Site: Del Webb@Mirehaven Phase 3 and 4

Re: Drainage Ordinance (14-5-2-1) Violations for Erosion and Sediment Control

North edge of site showing ineffective sediment BMP.

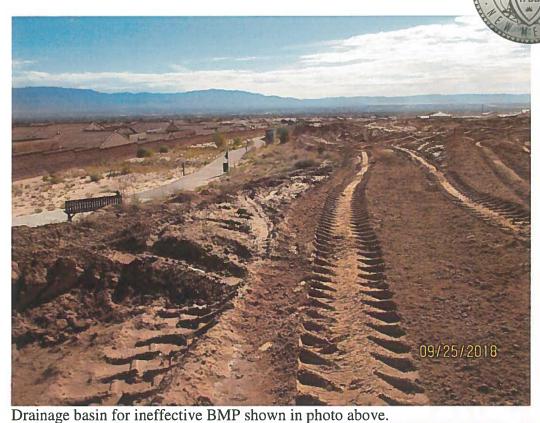
- 1. Along the north edge, the filter sock sediment BMP is in poor condition and would be ineffective.
- 2. The pond in the northwest corner for offsite flows has been filled-in, the area graded to drain to the street and there is no sediment BMP.
- 3. There was a dirt ramp in the street, workers are exiting onto the street in this location and this is a drainage conveyance with no sediment BMP.
- 4. On the north edge there is no sediment BMP at a drainage outfall location.
- 5. Sediment in gutters of Mirehaven Parkway at the south end of the project.
- 6. No sediment BMP on the north side of Mirehaven Parkway at the south end of the project between the curb and the path.

- 1. Provide a sediment BMP along the north edge where there is not a wall.
- 2. Provide a sediment BMP in the northwest corner where the pond has been filled-in that was graded for offsite flows.
- 3. Remove the dirt ramp (Abo Canyon and Red Butte) and do not build dirt ramps in the future. If egress onto the paved street is desired in this location, install vehicle tracking control. Divert drainage from dirt road towards a sediment BMP.
- 4. Provide a sediment BMP at the drainage outfall location south of Willow Canyon Trail.
- 5. Remove sediment from the gutters of Mirehaven Parkway at the south end of the project. Prevent sediment from accumulating to this amount in the gutters in the future.
- 6. Provide a sediment and/or erosion BMP on the north side of Mirehaven Parkway at the south end of the project between the curb and the path at the downhill end. See photo.

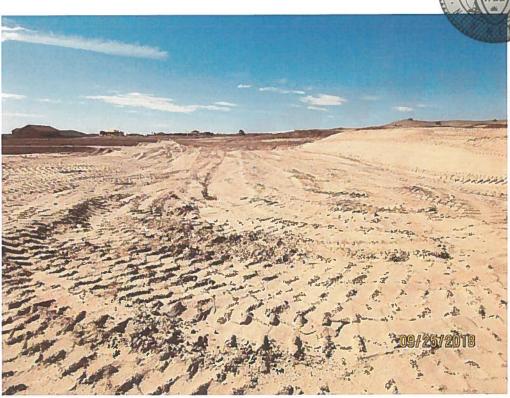
Dirt ramp in street, drainage conveyance with no sediment BMP and no track-out pad.

Outall location for medium sized basin with no sedimeth BMP. Location is south of Willow Canyon Trail.
